Access Compliance Report

Public Rights-of-Way

(Curb Ramps)

Intersection ID: 8030	Main Street: RUTGERS_AV	Cross Street: W_SUGAR_CREEK_RD	Location: SW
ADA ID: ECFE09DDC1E	Ramp Type: Para	Initial Pass/Fail: Fail	Overall Compliance: No
Severity Score: 13.75			
Codes/Mitigation Info/Possible Solution		Field Measurements/Component Compliance

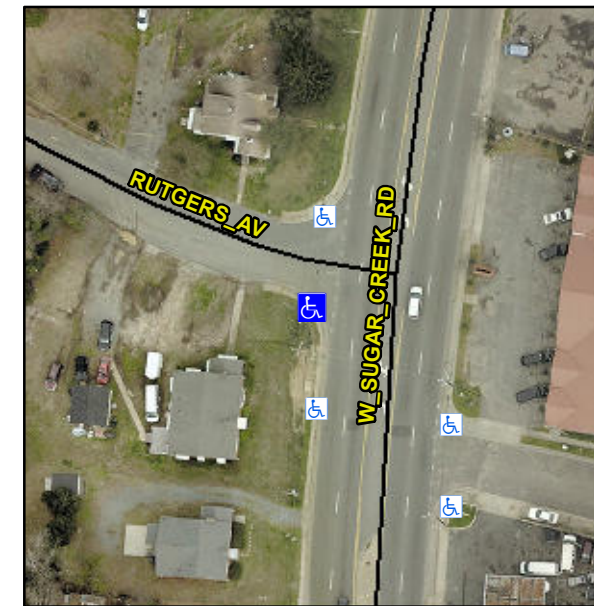
Surveyor Notes:

RT RP < 5%

PROW/ADA:

R304.3.2, R304.5.3

Possible Solutions:

Remove & Replace Entire Ramp.
